**Heavy duty vehicles: UN Regulations Nos. 49
(Emissions of compression ignition and positive
ignition (LPG and CNG) engines) and 132
(Retrofit Emissions Control devices (REC))**

Proposal for a new Supplement to 06 series of amendments to UN Regulation No. 49 (Emissions of compression ignition and positive ignition (LPG and CNG) engines)

Submitted by the expert from the International Organization of Motor Vehicle Manufacturers*

Figure 12

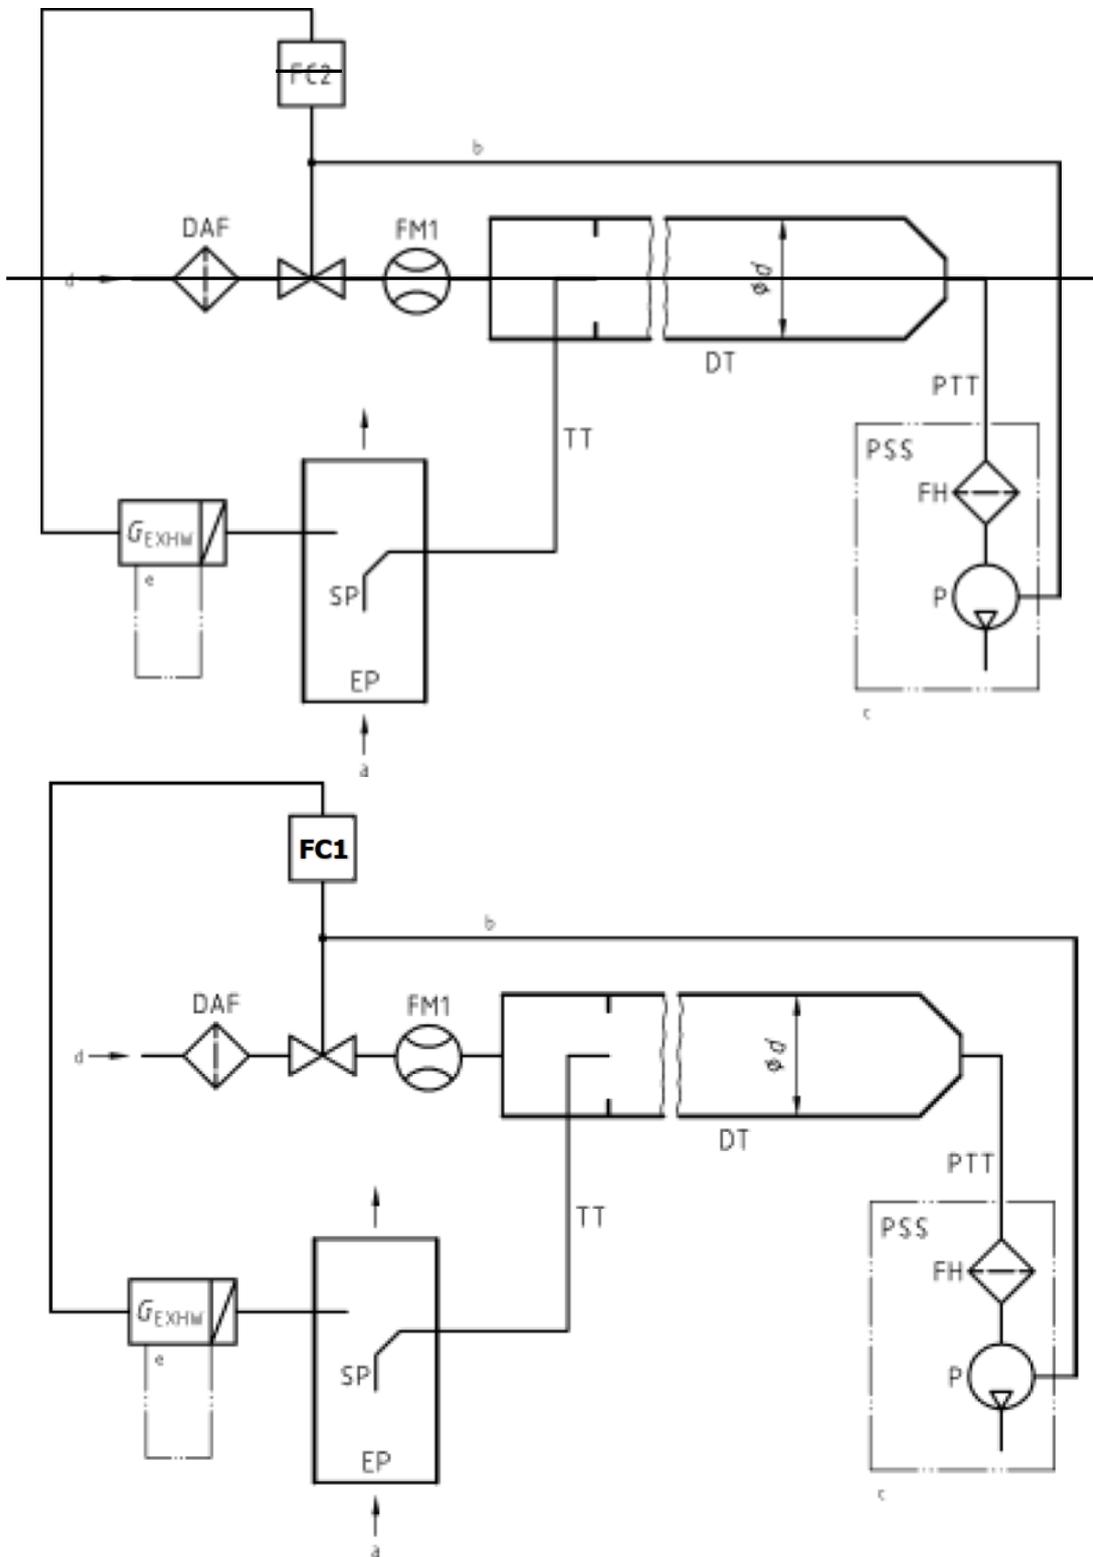
In the text, the flow controller is represented by “FC1”, whereas in Figure 12, it is “FC2”. Therefore, it is necessary to correctly set “FC1” in Figure 12.

Paragraph A.2.2.1., amend to read:
